Discussion.

DIAGRAM OF TIDES DURING DECEMBER, 1894.

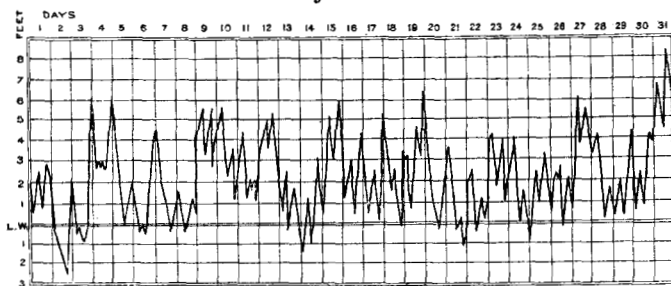
anchorage and Montevideo, as there was at present in many parts Mr. Dobson. of the course, and in front of Montevideo, as stated by Mr. Hawkshaw, only 21 feet below zero. With reference to Mr. Meldrum's question as to the level of the water in the docks in 1890, on the date to which he referred, the level of the water should have been zero or low water, giving 23 feet 9 inches in dock No. 1, which was the only dock opened; and this proved the advantage of having lock-gates, as the level of the water in the river, as stated in the Paper, was 8 feet 2 inches below zero, consequently all the steamers in the South Basin, which was tidal, were aground. Replying to the remarks made by Mr. L. F. Vernon-Harcourt, the whole of the water could be changed, as stated in the Paper, because, although the water was not allowed to fall below zero, the gates were left open sometimes for days together, and only closed when the necessity arose, either for sluicing purposes or for retaining the water at the zero level, when a low tide was expected. With regard to the floats referred to, it would be hardly necessary for the Author to state that proper floats were used to find the rate of the current; they each consisted of a flat piece of wood, to which a line 15 feet in length was attached, having at its lower end a sack filled with shavings, and loaded with sufficient stone to sink it to the proper depth, so that the float was controlled by the lower current, and not appreciably affected by the wind or surface current. The current was naturally greater through the passages than in the docks. The floats were tried at almost every time of tide. The current through the docks was such that the bottom of the lock sills at both ends, the bottom of the passages, and the docks down the centre, were perfectly free from silt. As to the depth of the sills in the north lock, to this the Author had already replied, but it might be as well to add that the tendency to-day was to build larger ships, but drawing less water, for the navigation of the River Plate.

SECTION OF PROPOSED DOCKS AND RIVER-WALL.

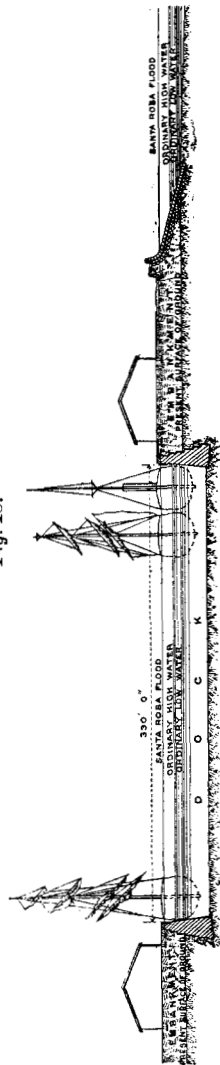
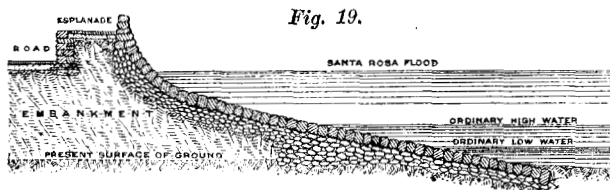
warehouses, and graving-docks as built. The section of Mr. Bateman's basin, *Figs. 18 and 19*, showed stone walls, and not timber, as would be inferred from Mr. Parsons' remarks, and a pitched slope, which, in section, was shown to be 21 feet 4 inches below low water, while the depth of the dock was only 20 feet below low water, and not 23 feet 9 inches, which was the case in the docks now constructed. As to the storm-water conduits which were intended to be discharged into the proposed basin, and which discharge it was estimated would amount to some 457,000 cubic metres of water per hour, the late Sir John Hawkshaw and Mr. Hayter were strongly opposed to the storm-water drains being discharged into the docks, on account of the large amount of sewage and other material which came down those drains. At the conduit at Calle Garay there was always over 18 inches of sewage for a great distance in the open cut during the whole
